Newcastle Inner City Bypass
Rankin Park to Jesmond

**Newcastle Inner City Bypass –
Rankin Park to Jesmond
Submissions and preferred
infrastructure report**

June 2018

Figure 5-5
 Southern interchange – pedestrian and cyclist facilities

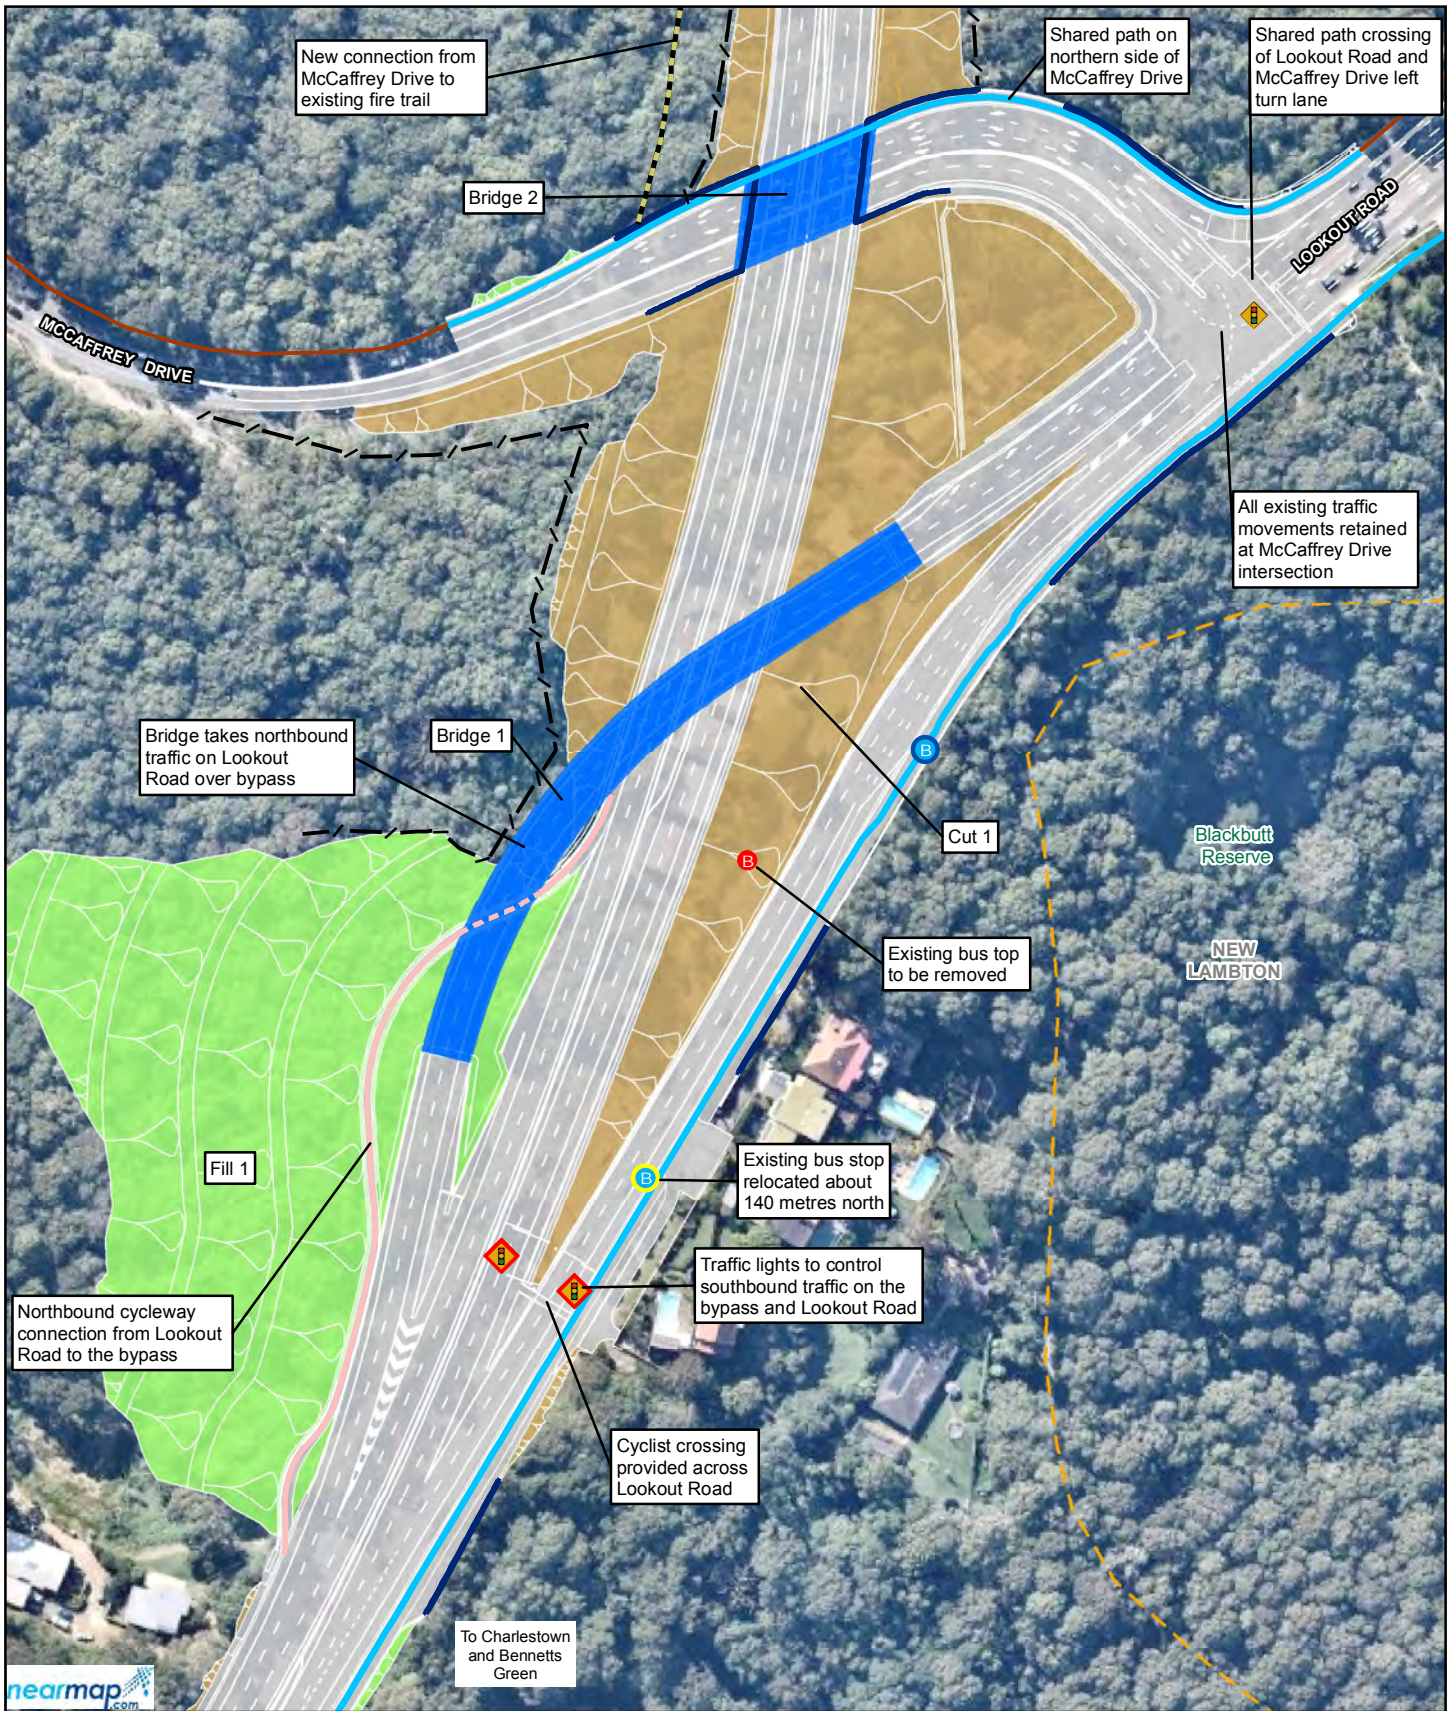
The project would now provide a new northbound cycleway connection (one way only) as shown in Figure 5-5. This enables northbound on-road cyclists to exit Lookout Road and pass beneath the flyover before re-joining the northbound road shoulder of the bypass.

The existing footpath would now be replaced with a three metre wide shared path for use by both pedestrians and cyclists as shown in Figure 5-5. The shared path would be three metres wide and would connect with existing footpaths on Lookout Road and McCaffrey Drive.

The existing pedestrian only crossing point on the northern side of the Lookout Road and McCaffrey Drive intersection would now be replaced with a shared path crossing for use by both pedestrians and cyclists as shown in Figure 5-5. The existing crossing of the left turn lane from McCaffrey Drive onto Lookout Road, would also now be a shared path crossing controlled by traffic lights.

Figure 5-8a
 Construction ancillary facilities

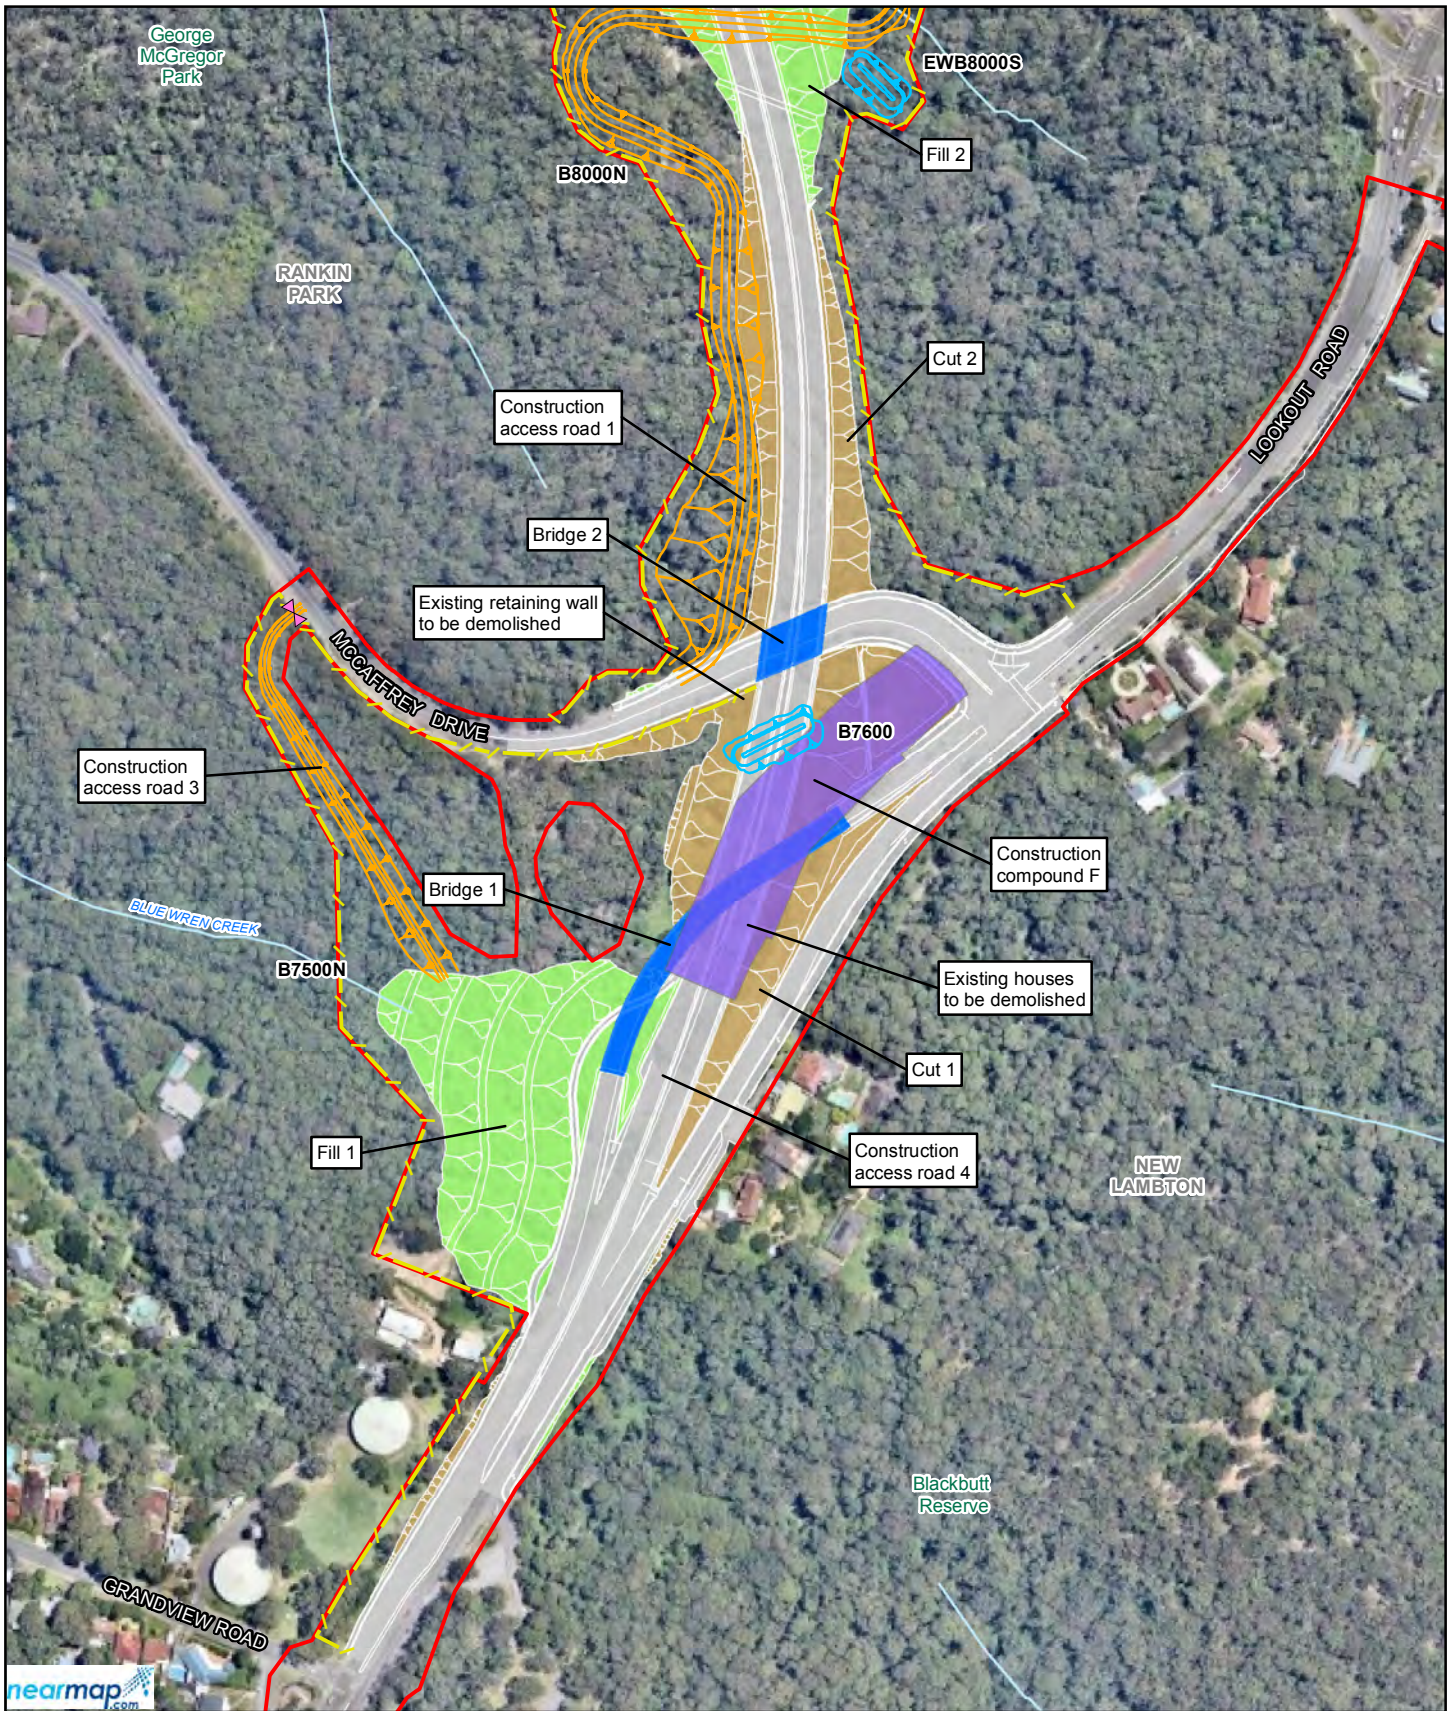
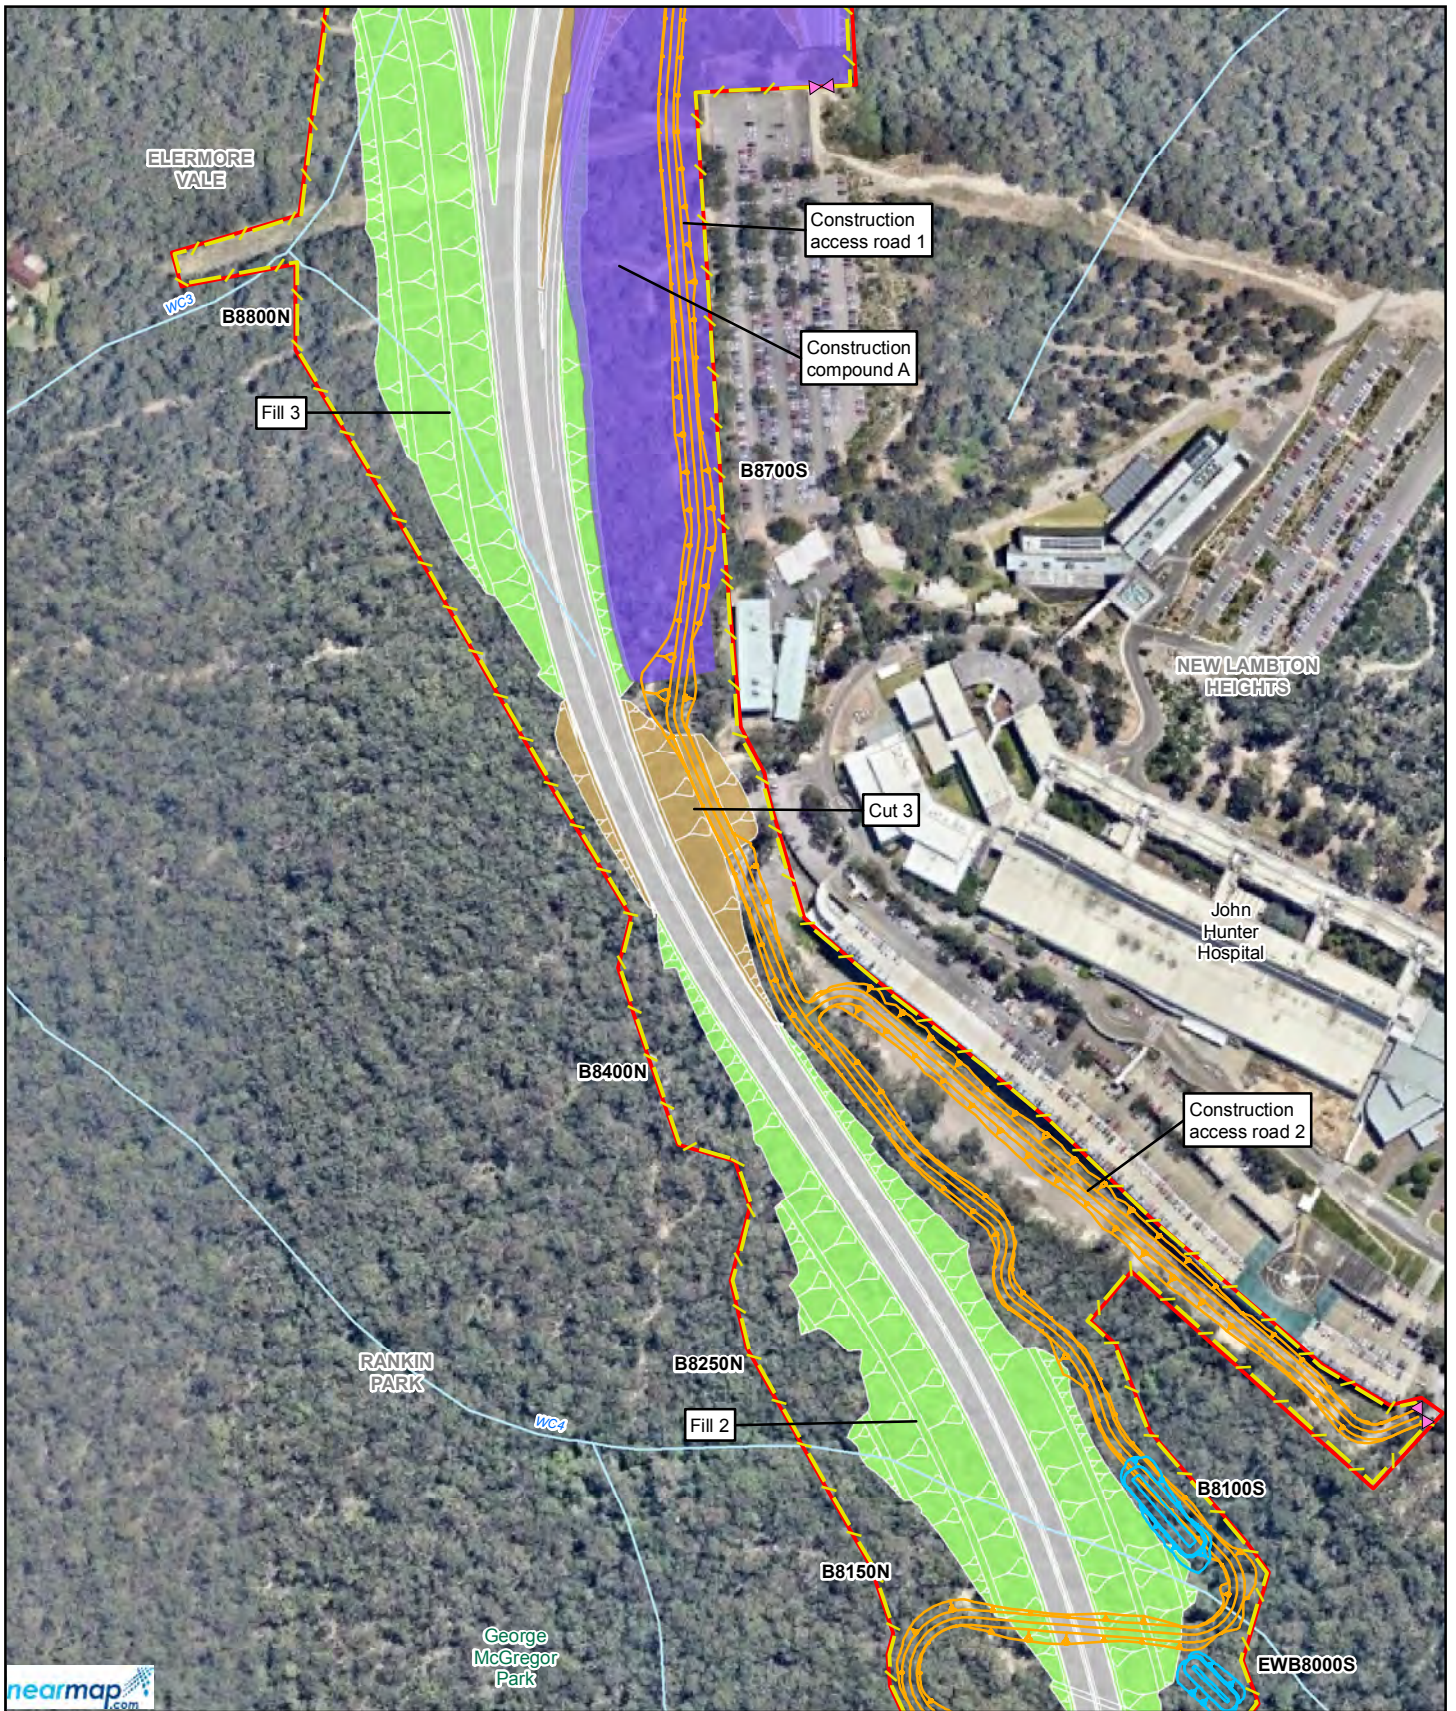
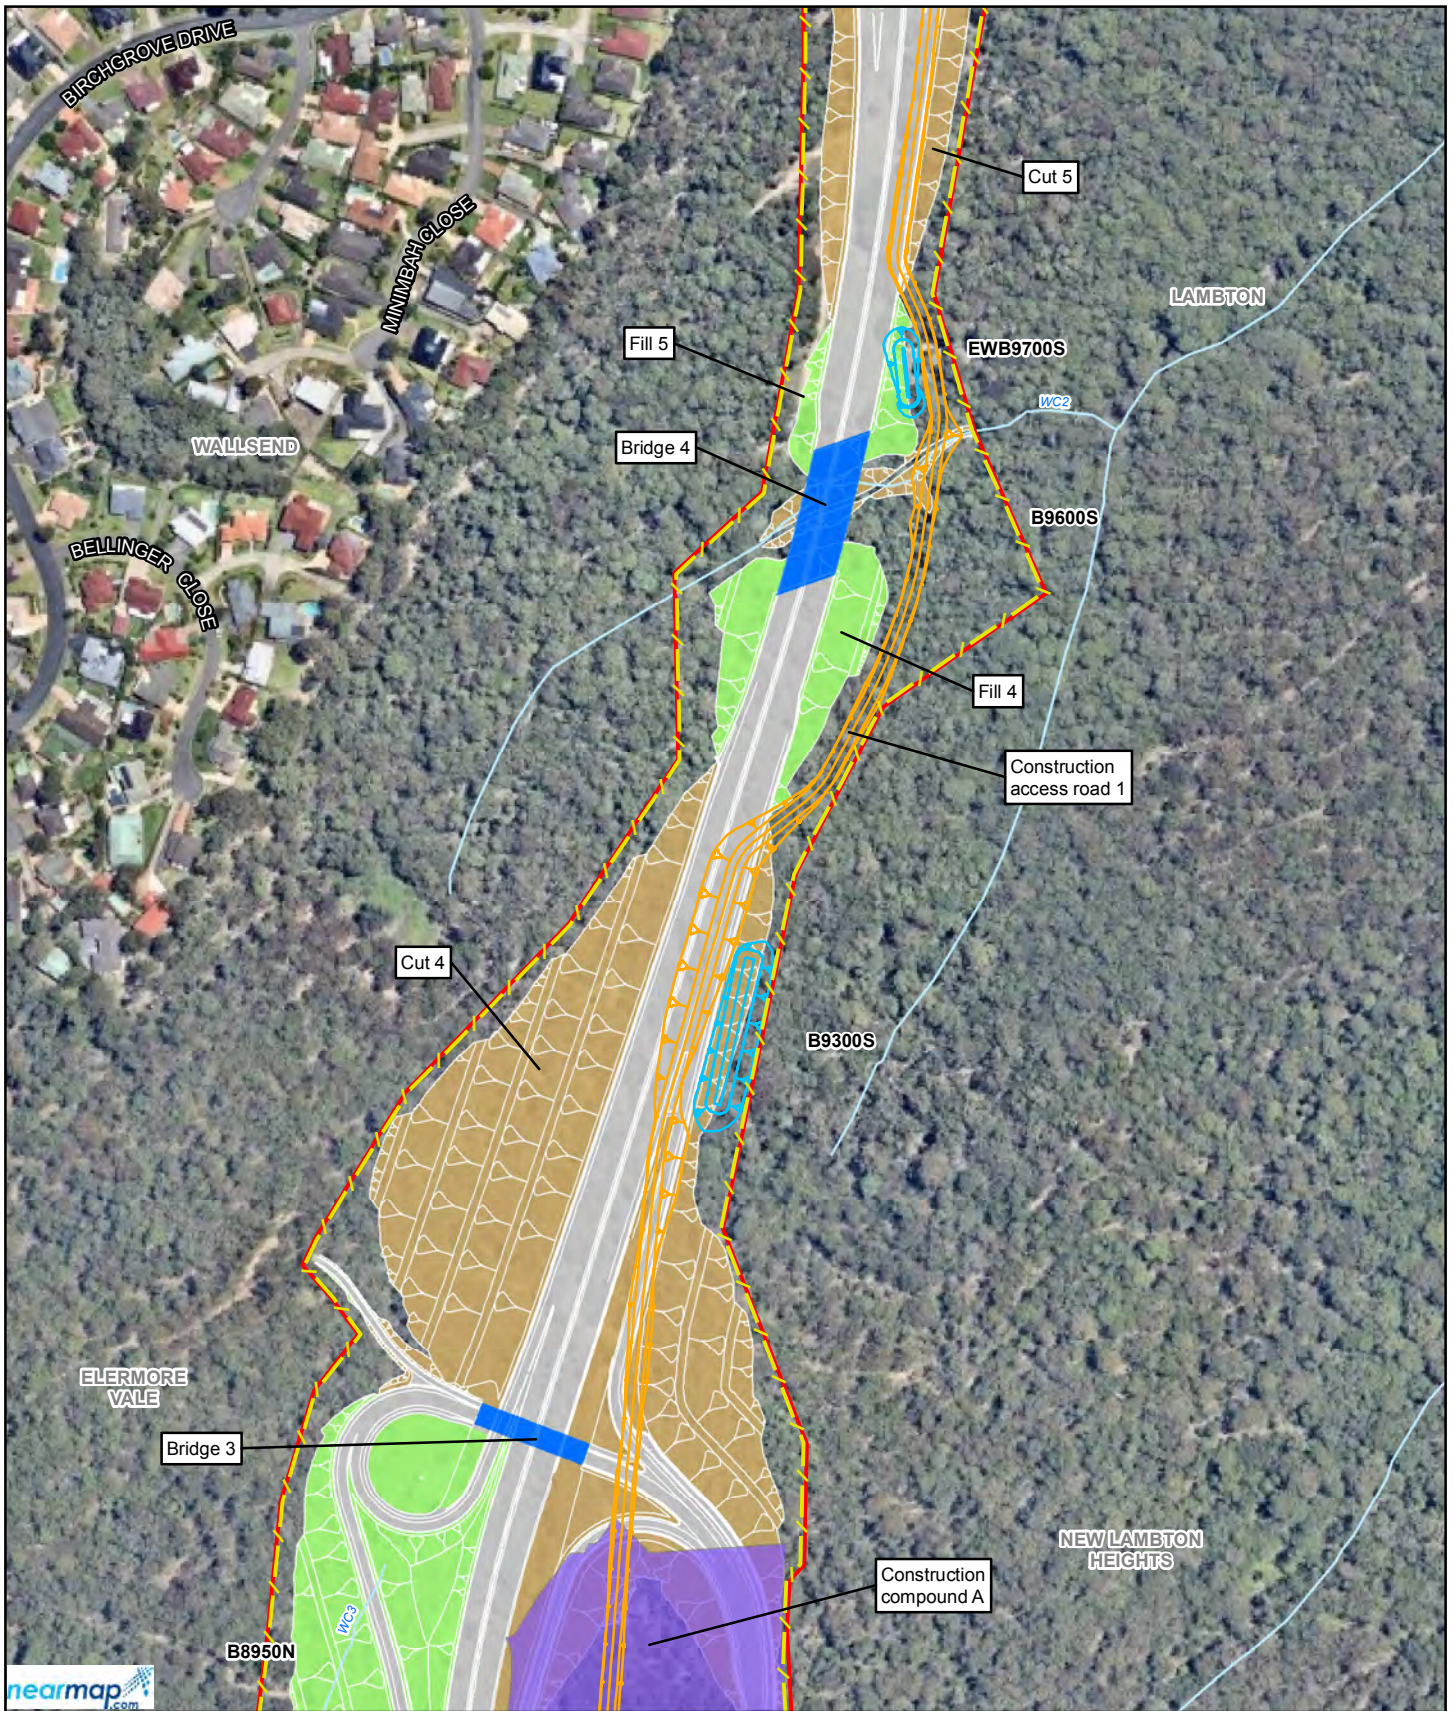
The locations of the construction compounds are shown in Figure 5-8 and a description is provided in the following sections. They have been located based on:

Compound D (new compound) is about 0.2 hectares in area and is located near the eastern end of Jesmond Park on the southern side of Newcastle Road (Figure 5-8). Access to this construction compound would be via Robinson Avenue and/or temporary access arrangement from Newcastle Road.

Compound E (new compound) is about 0.1 hectares in area and is located near the intersection of Coles Street and Steel Street on the northern side of Newcastle Road (Figure 5-8). Access to this construction compound would be via Steel Street, Coles Street and/or temporary access arrangement from Newcastle Road.

Compound F (new compound) is about 0.9 hectares in area and is located near the southern interchange on the western side of Lookout Road (Figure 5-8). Access to this construction compound would be via Lookout Road and/or McCaffrey Drive.

Due to other design refinements, during construction there will be still be about 16 sedimentation basins but some would be in new locations to capture sediment laden runoff from construction areas (Figure 5-8).
